City of Portland, Maine - Building or Use Permit Application 389 Congress Street, 04101, Tel: (207) 874-8703, FAX: 874-8716

Permit No: **9 80565**

Location of Construction: **29 Harmon Rd** Owner: **Mechelle Turcotte Connolly** Phone: **772-6342**

Proposed Project Description: **Construct deck** Signature: **PEDESTRIAN ACTIVITIES DISTRICT (P.A.D.)**

DECK FRAMING (UPPER PORTION)

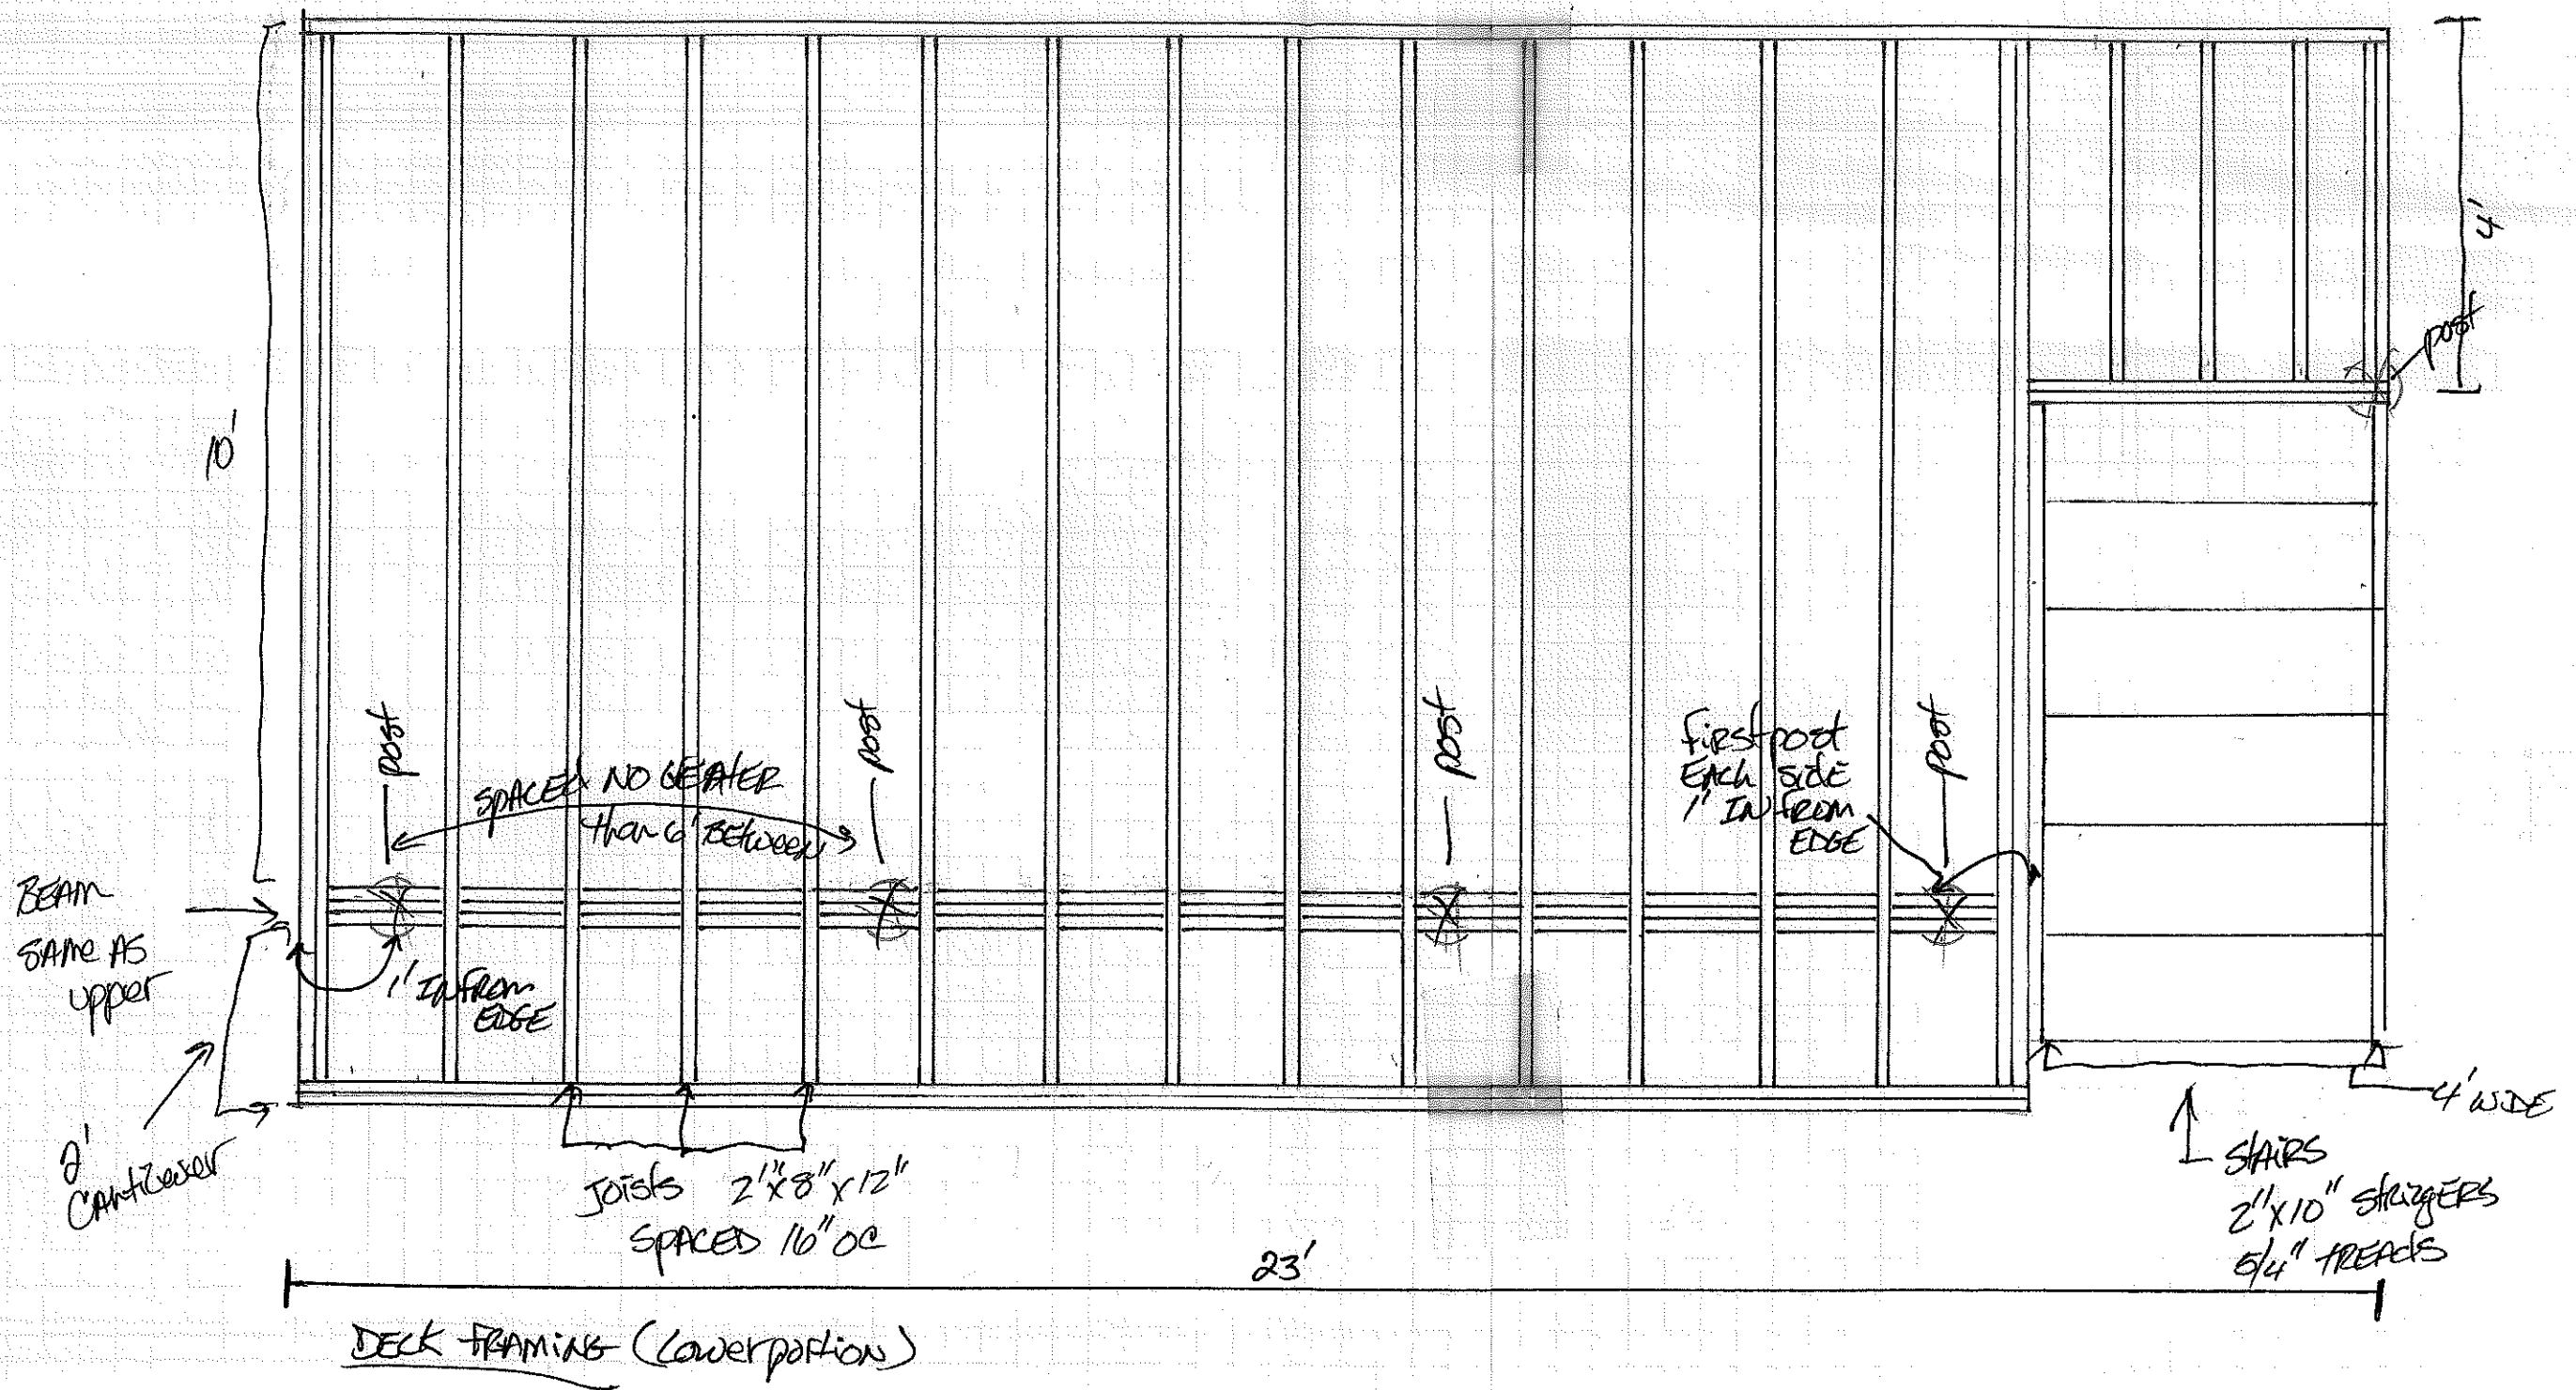
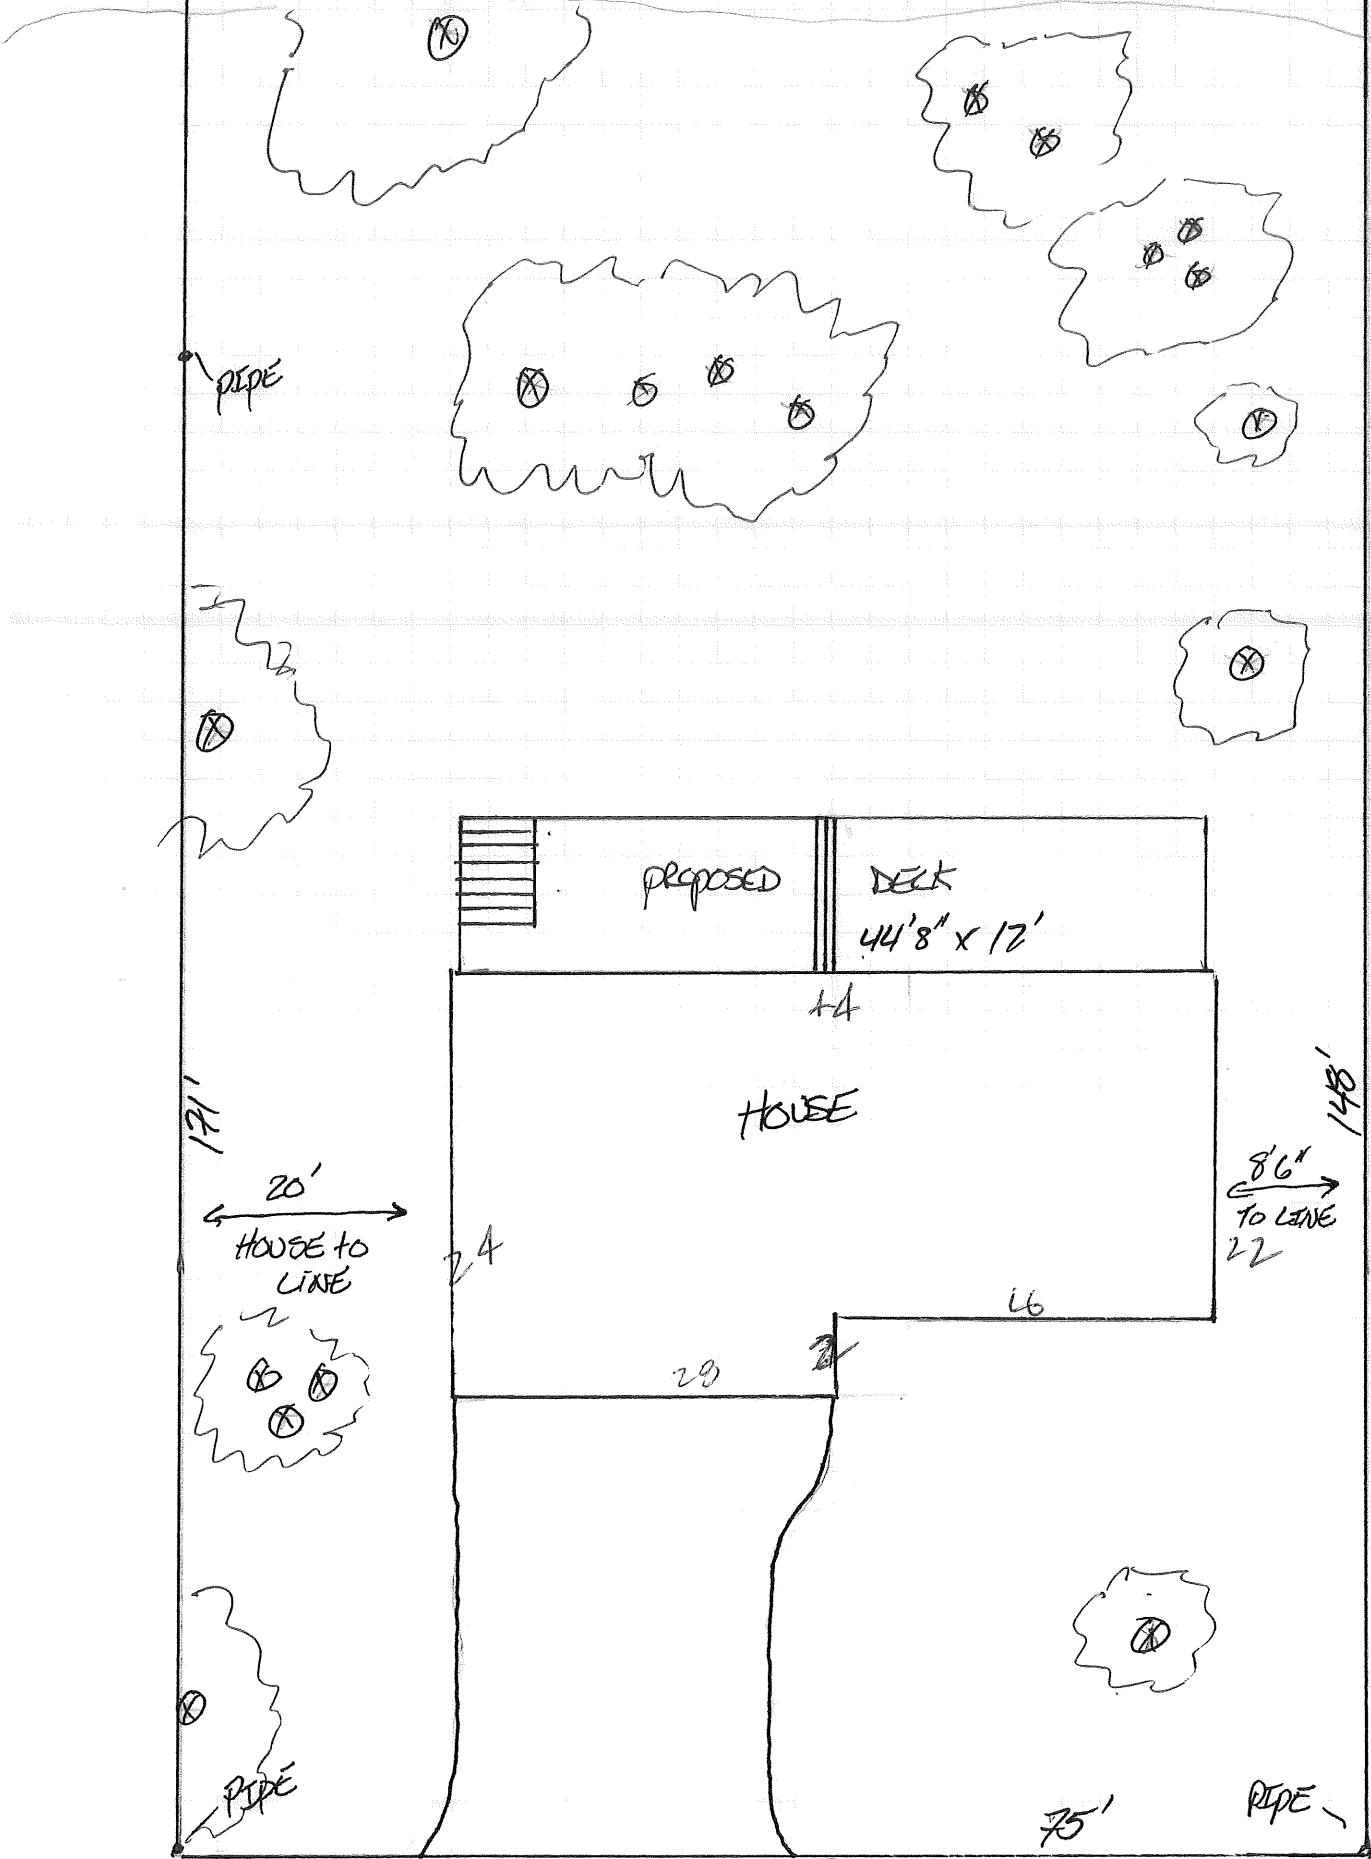
Frame Breaks Need to Be Plated 4' Each way For an sup posted Deck per lin Framing

SIDE ELEVATION

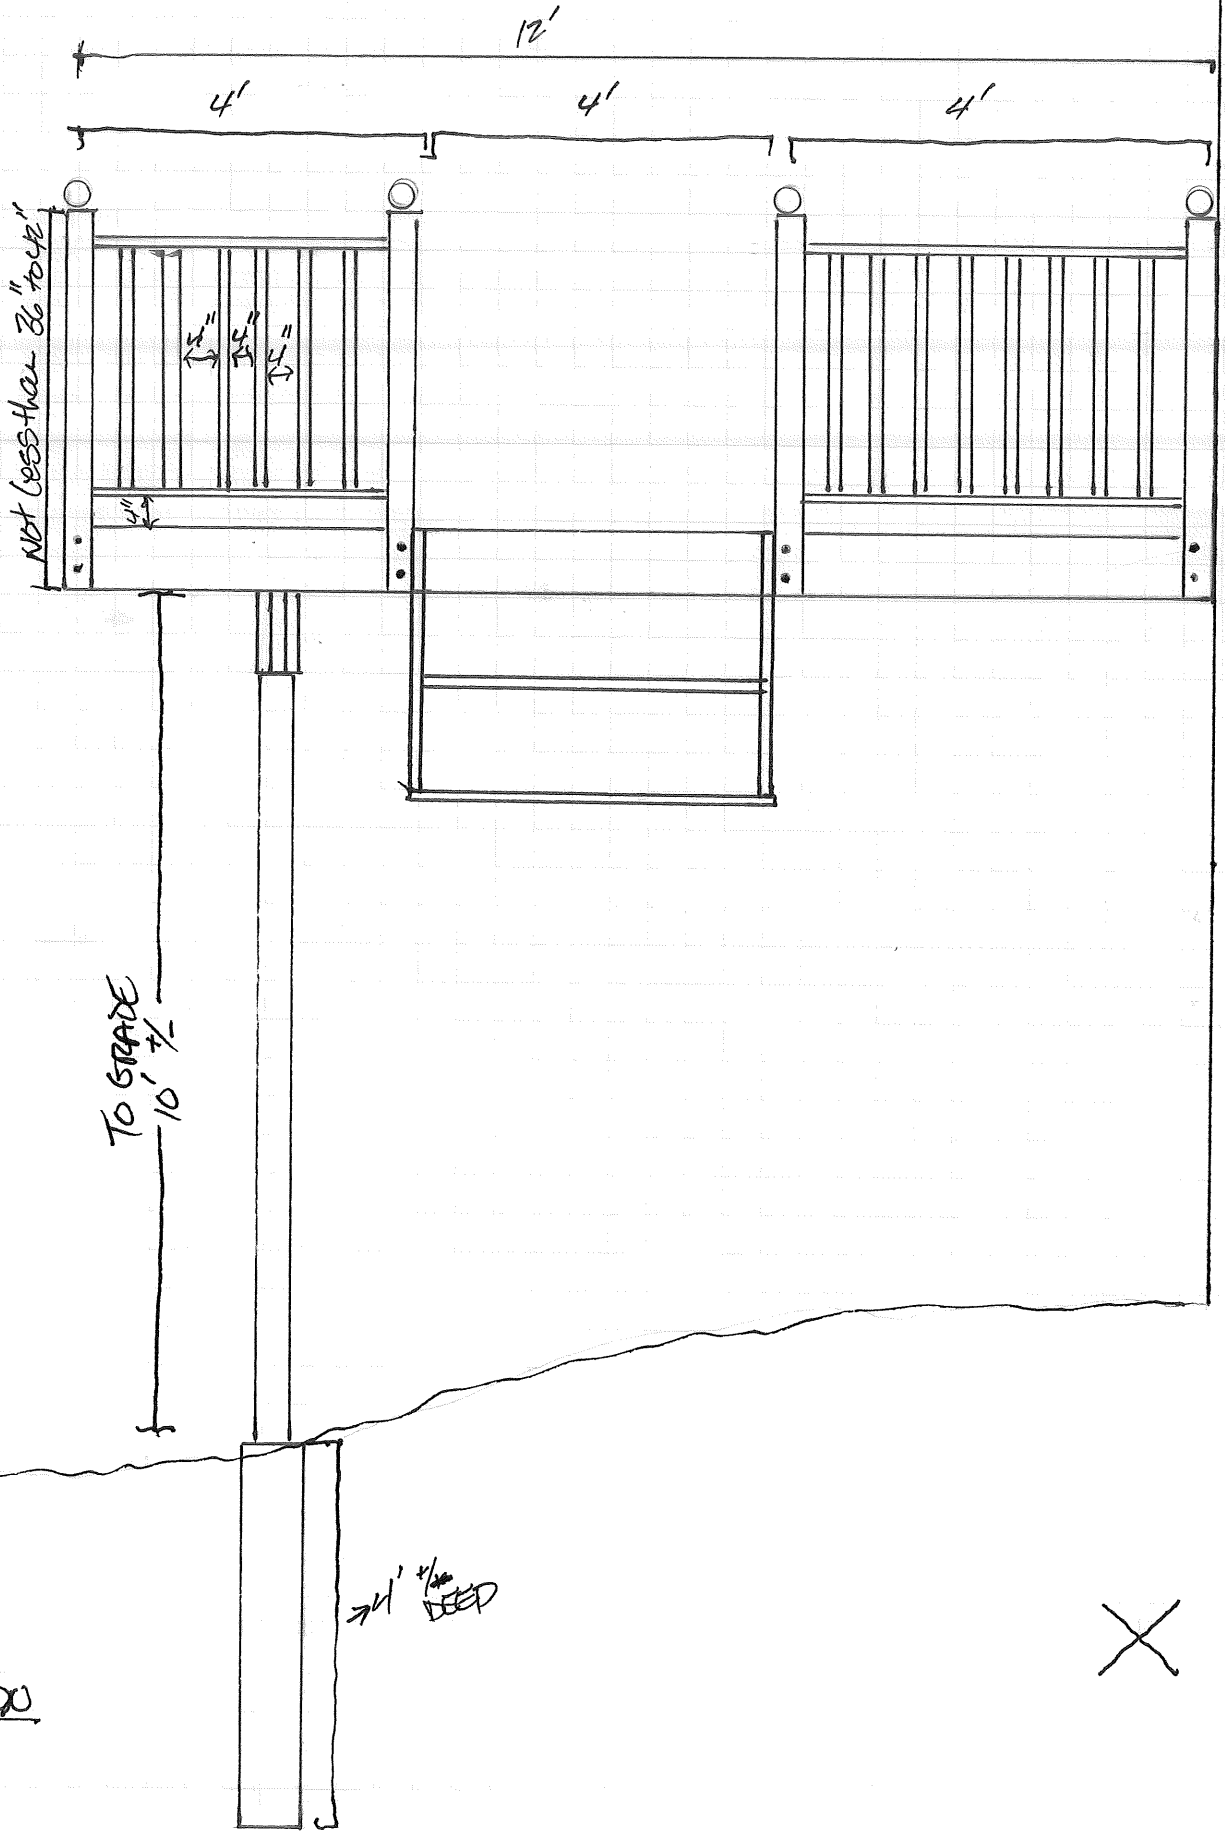
7-27-98 Returned for Final hand Rails all 4 1/2" F

are at 39 1/2" and are not Grippable may add to

Both sets of stairs.

Treads are 11" wide and 8 1/2 high 1/2" a 11 of them

Lower deck Guard Rail Needs to extend ~~20~~ more inches and all Guard Rail Post need to be tight in the Deck Frame

7-15-98 Parklins fixed ok to Close out MW
